In-vehicle battery durability e-HDVs

Open Items

Elena Paffumi, Gian-Luca Patrone
EVE IWG 70th , web-meeting,
May 7th-8th , 2024

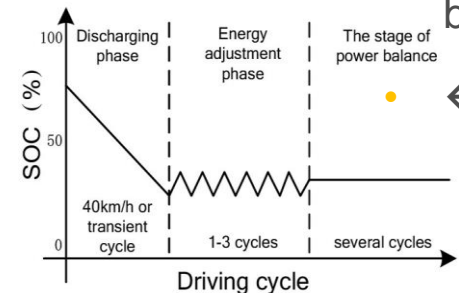
← China proposal

Japan: at least 1500sec ?
 JE05 : 1830 sec
 WLTP 4 : 1800 sec
 WLTP 3 : 1477 sec

Japan: 4 per cent of cumulative UBE

Method 1a Discharge by standard average speed on a test track

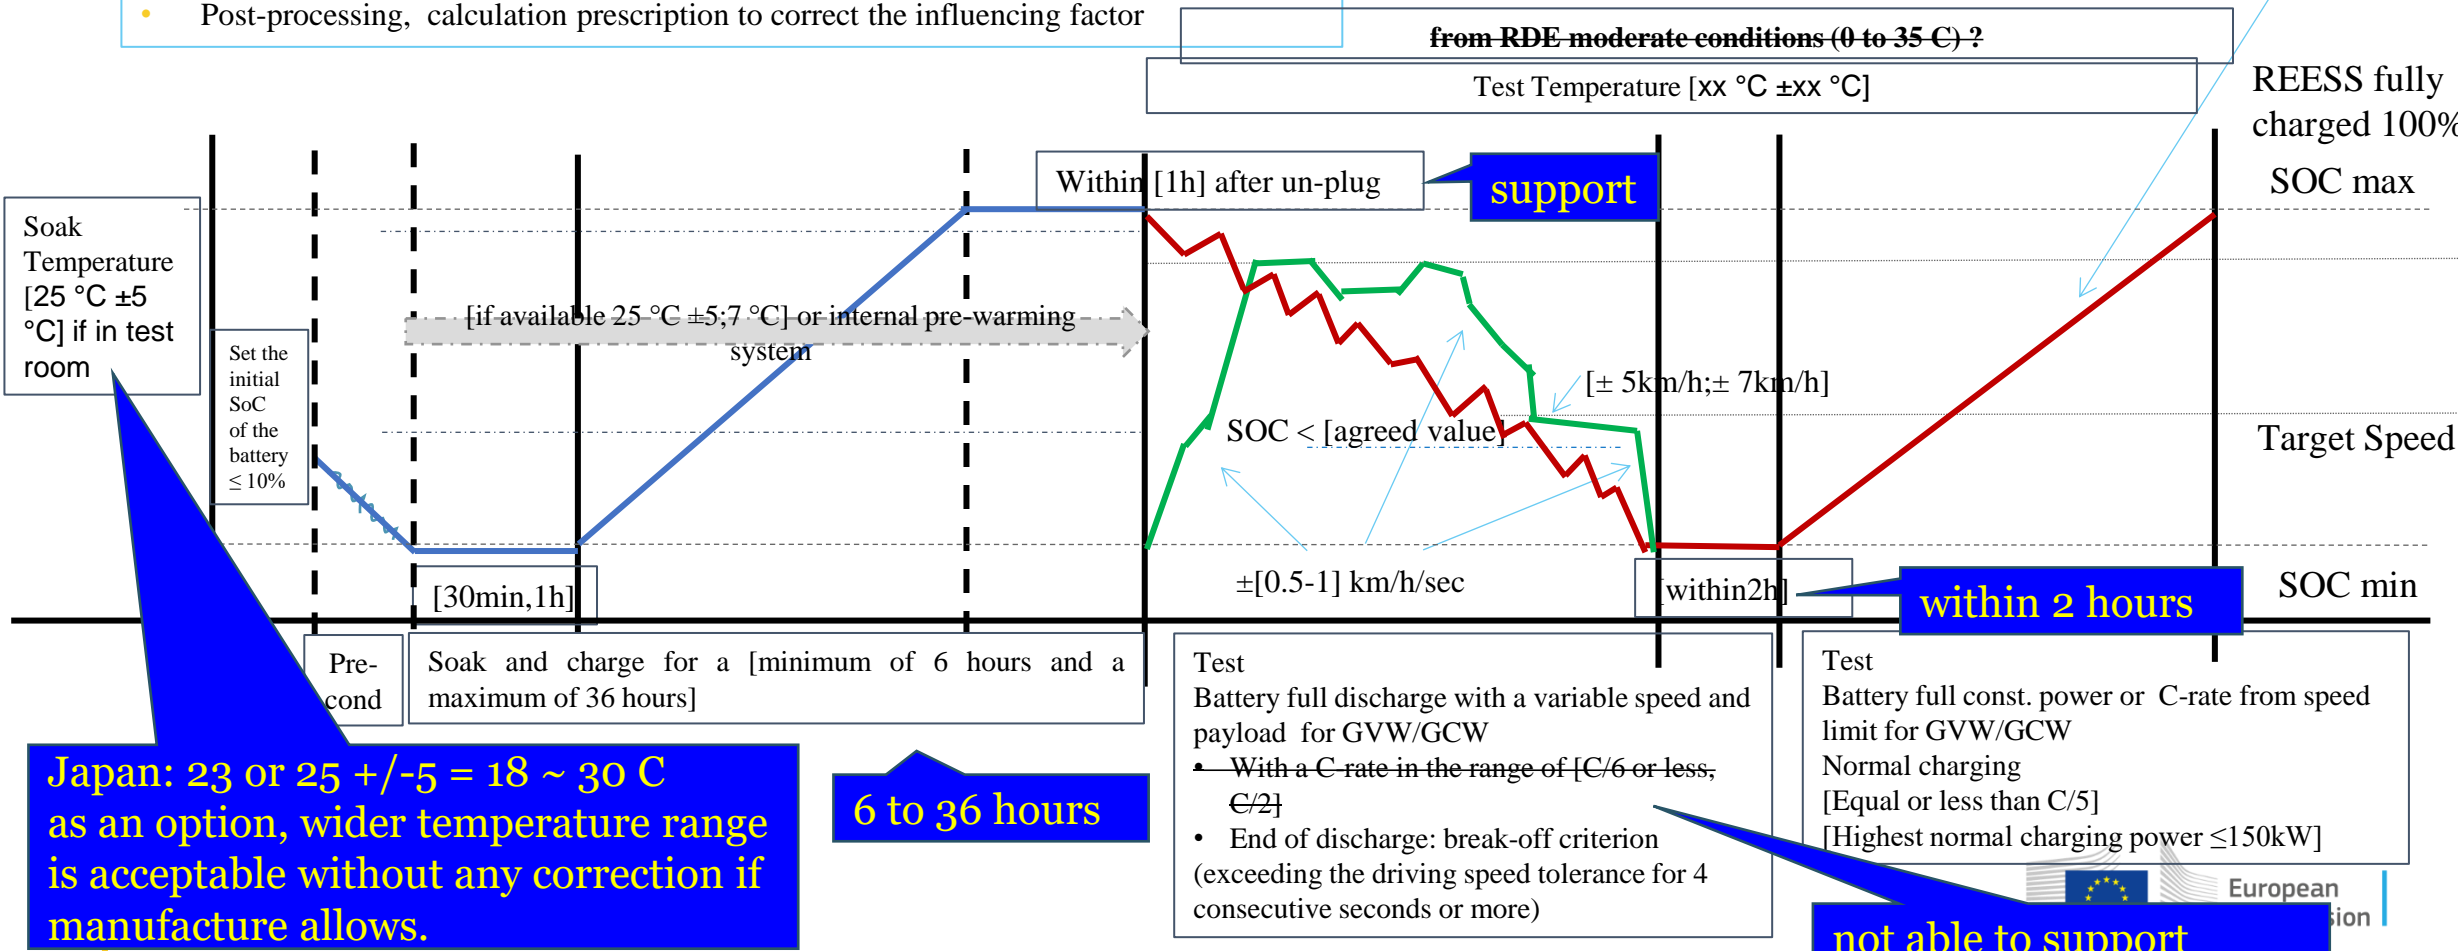
- Range of speed per category per region track
- To leave open the speed for the test and prescribe only the target speed in the last part of the test for which a speed tolerance will be applied
- The last part of the test starts when the SOC < [10%] (to be verified)
- Speed tolerance in last test segment [$\pm 5\text{km/h}; \pm 7\text{km/h}$]
- The acceleration/deceleration during vehicle speed change shall be smooth and accomplished within the range $\pm[0.5-1]$ km/h/sec
- End of discharge: break-off criterion
- Temperature provision due to cold temperature effect

from RDE moderate conditions (0 to 35 C)?

Japan: 23 or 25 +/-5 = 18 ~ 30 C as an option, wider temperature range is acceptable without any correction if manufacture allows.

not able to support

Method 2 bidirectional charging system available

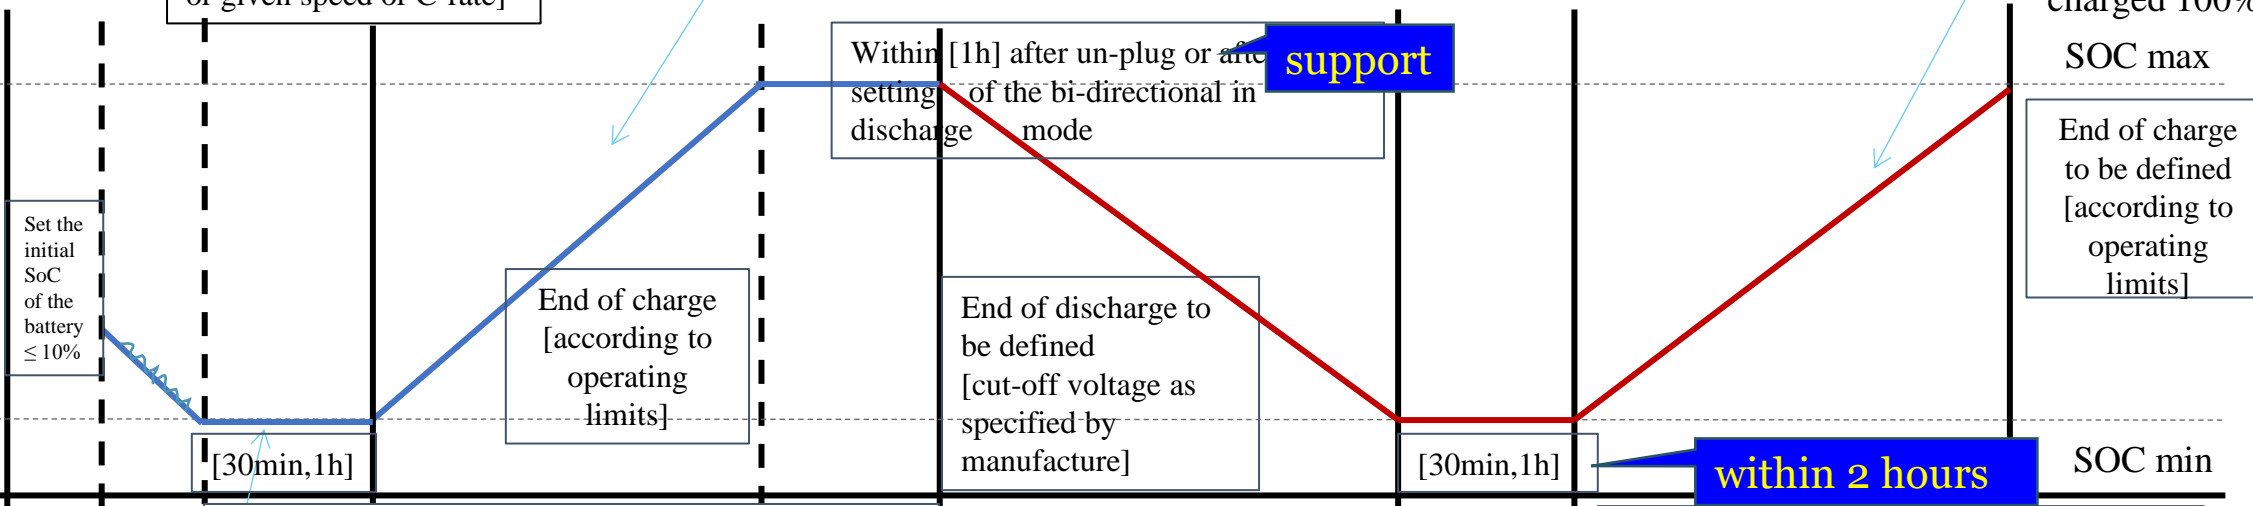
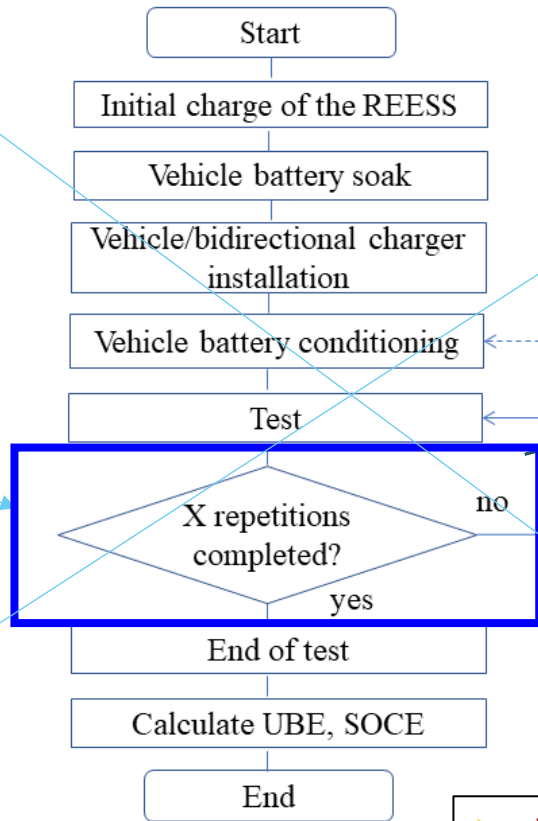
Japan: 23 or 25 +/- 5 = 18 ~ 30 C as an option, wider temperature range is acceptable without any correction if manufacture allows.

within 0 ~ 35 C

follow manufacture recommendation

not able to support

End of discharge to be defined for bi-directional charging test [Cut-off voltage]
